REGULATORY INFORMATION DISTRIBUTION SYSTEM (RIDS)

SUBJECT: Responds to Insp 50-244/90-24 on 910114 re "Review of RG&E
Actions Taken in Response to NRC Bulletin Number 88-04,
Potential Safety Related Pump Loss."

Subject: Response to Inspection No. 50-244/90-24,
dated January 14, 1991
Review of RG&E Actions Taken in Response to NRC Bulletin
No. 88-04, Potential Safety Related Pump Loss
R.E. Ginna Nuclear Power Plant
Docket No. 50-244

BASIS OF DESIGN FOR THE MINIMUM FLOW
RECIRCULATION SYSTEMS FOR RESIDUAL HEAT
REMOVAL, HIGH HEAD SAFETY INJECTION, AND
AUXILIARY FEEDWATER PUMPS AS RELATED
TO NRC BULLETIN 88-04

FIGURE A-2
MODIFICATION SCHEMATIC
AS INSTALLED PER EWR 3881

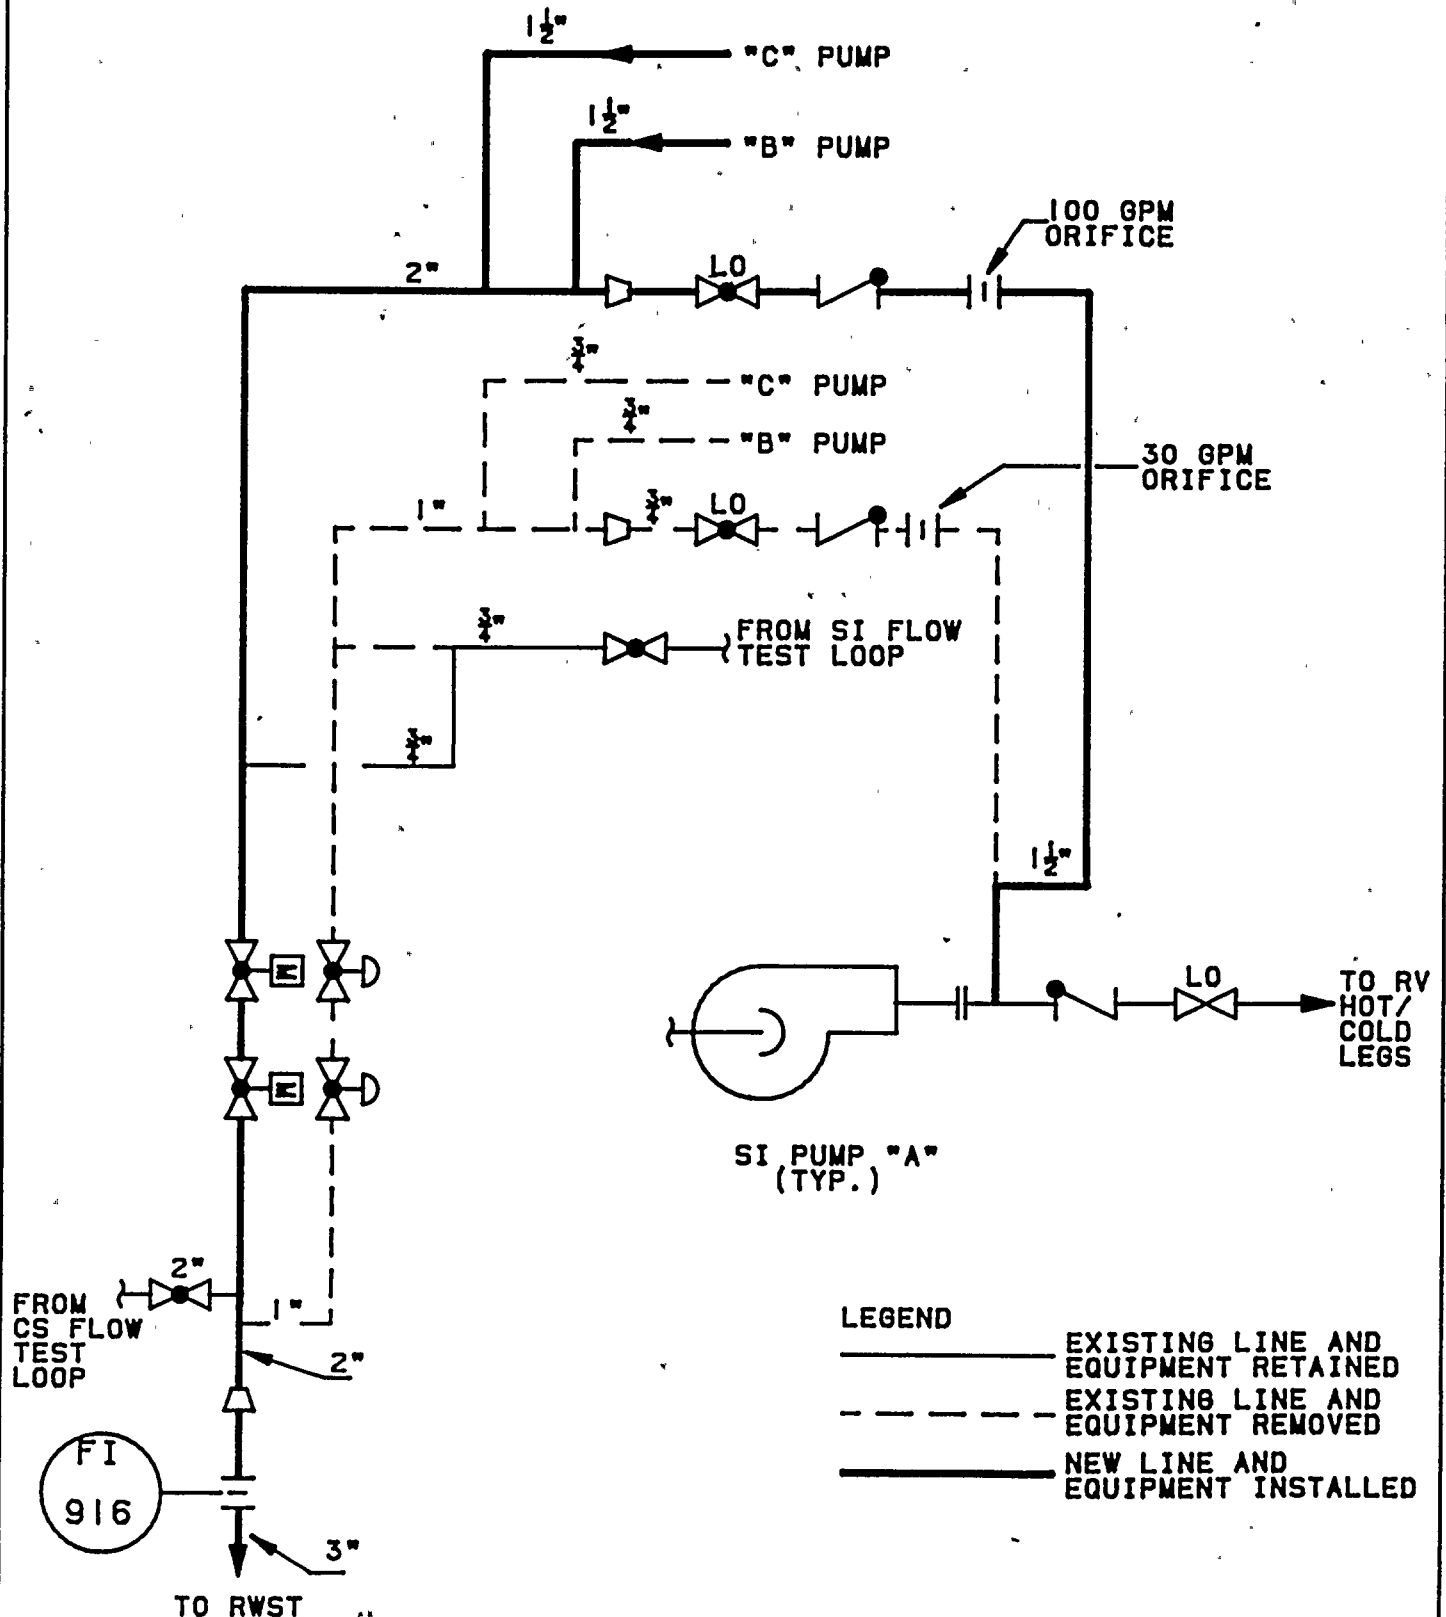
Additionally, it was noted that the as-built recirculation line for the High Head Safety Injection System did not agree with that proposed in our response to NRC Bulletin 88-04, dated July 7, 1988. Modification (EWR) 3881 was implemented in 1989 to provide a 1½-inch recirculation line for each pump. Our response had indicated a 1-inch line would be installed.

The use of the 1½-inch line was documented in modification package for EWR 3881 and a description was also provided in our December 1989 update of the UFSAR in Section 6.3.2.2.1. The as-built system configuration is shown on the Piping and Instrumentation Drawing provided as Figure 6.3-1 of the UFSAR.

RG&E designed and installed the plant modification (EWR 3881) so as to provide a recirculation flow of 100 gpm for each pump through a fixed orifice. The modification replaced the 3/4" recirculation piping with 1 1/2" pipe. (See Figure A-2 attached). Each pumps recirculation piping comes together in a common 2" header. Since the tie-in is downstream of the fixed pressure breakdown orifices, there will not be a pump-to-pump interaction as described in Bulletin 88-04. Hence, the systems are independent in the context of Bulletin 88-04. (The original design depicted in ref. (h) contained 1" lines in lieu of 1 1/2" as described above).
